# CITY OF SACRAMENTO

- SUBJECT: 1. Final Environmental Impact Report on Del Paso Park Master Plan Implementation Program
2. Del Paso Regional Park Revised Master Plan

RESOLUTION ADOPTING THE FINAL ENVIRONMENTAL IMPACT REPORT FOR THE DEL PASO REGIONAL PARK MASTER PLAN IMPLEMENTATION PROGRAM AND THE REVISED DEL PASO REGIONAL PARK MASTER PLAN

RESPONSE TO COMMENTS ON THE FINAL EIR

Mc CLELLAN AFB  
PLANNING BOUNDARY  
MAP  
(AIRPORT AREA OF INFLUENCE)

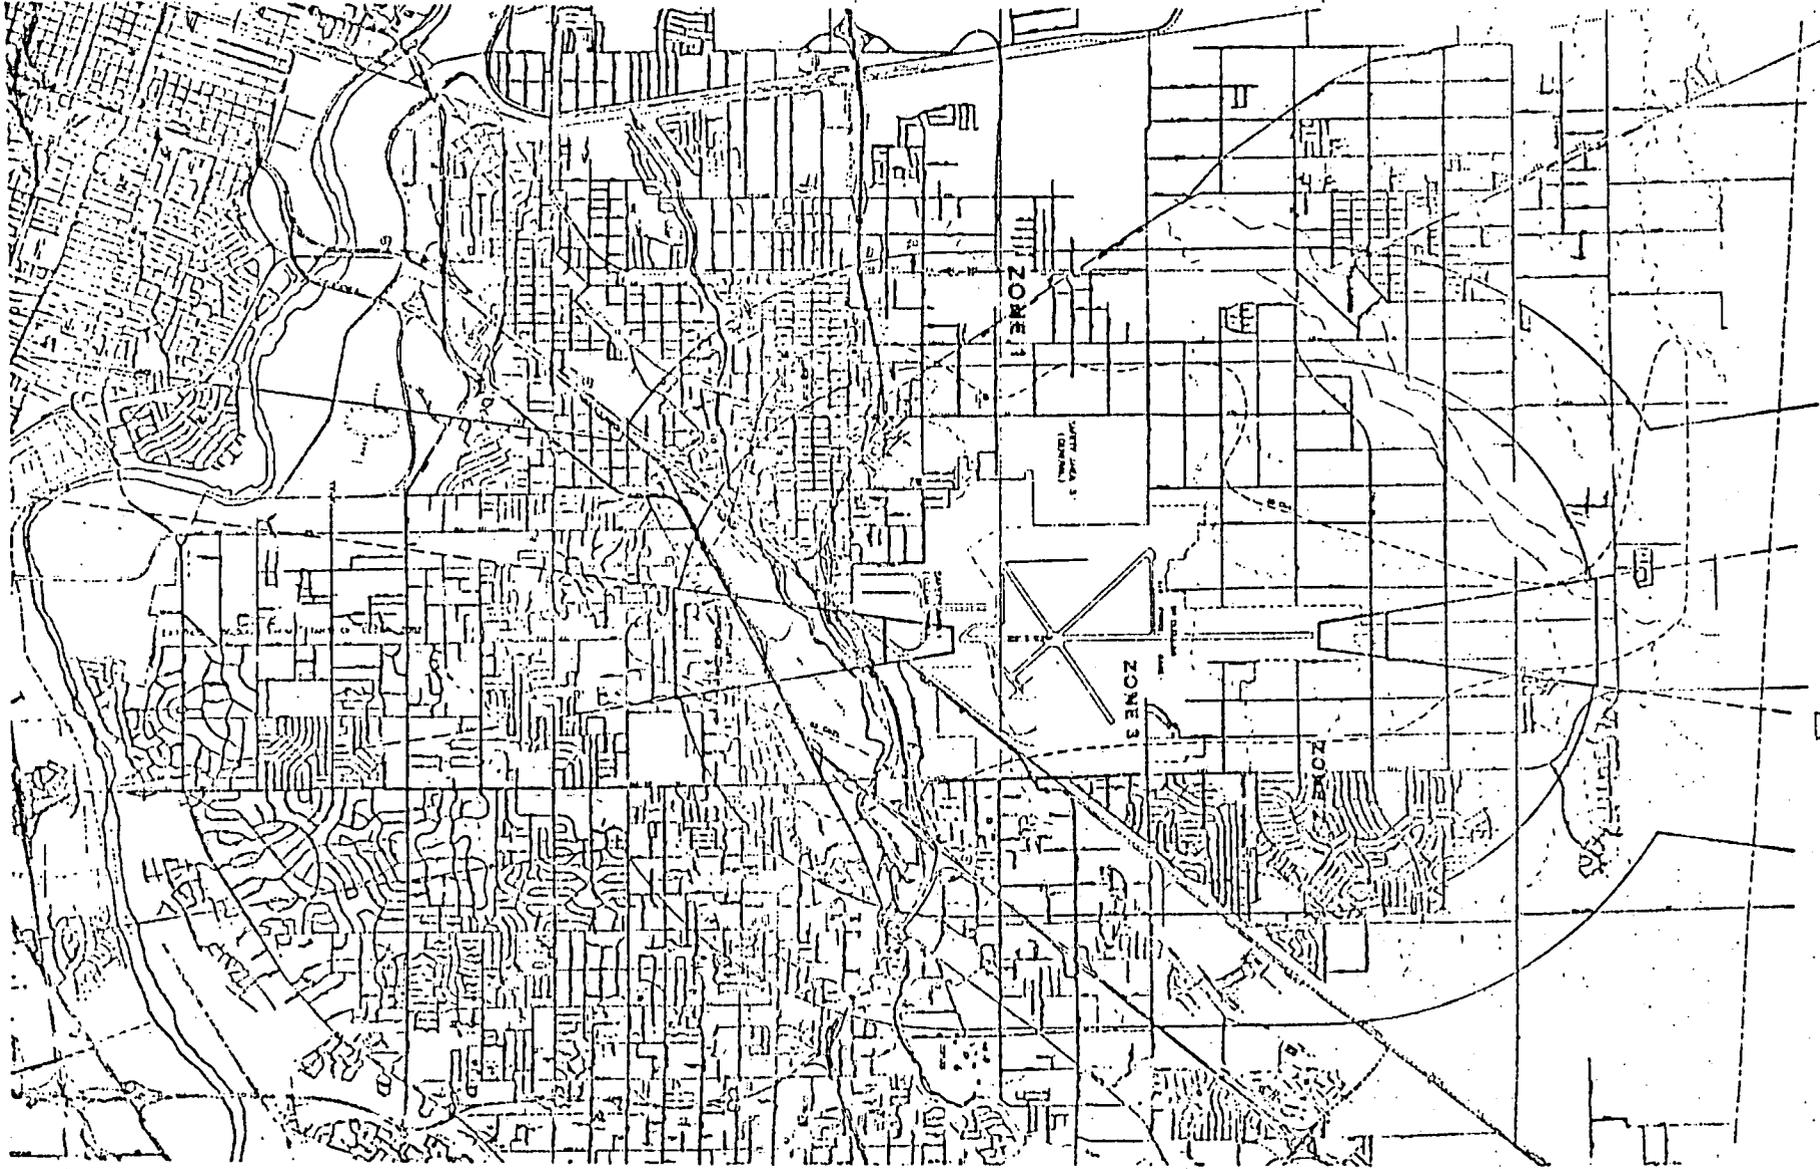
1. Revised Exhibit D-2 (p. 10) now titled "ALUC Constraints (Revised)" is incorrect. This map shows clear zone, approach zone and noise contours from the McClellan AFB Air Installation Compatible Use Zone (AICUZ) Study and not the ALUC planning boundaries for McClellan. An ALUC planning boundary map for McClellan is enclosed.

Revised Exhibit D-2 was incorrectly labeled. The map showed McClellan AFB Air Installation Compatible Use Zone (AICUZ) information rather than ALUC planning boundaries. The ALUC map has been printed along with the comment letter for clarification of this error.
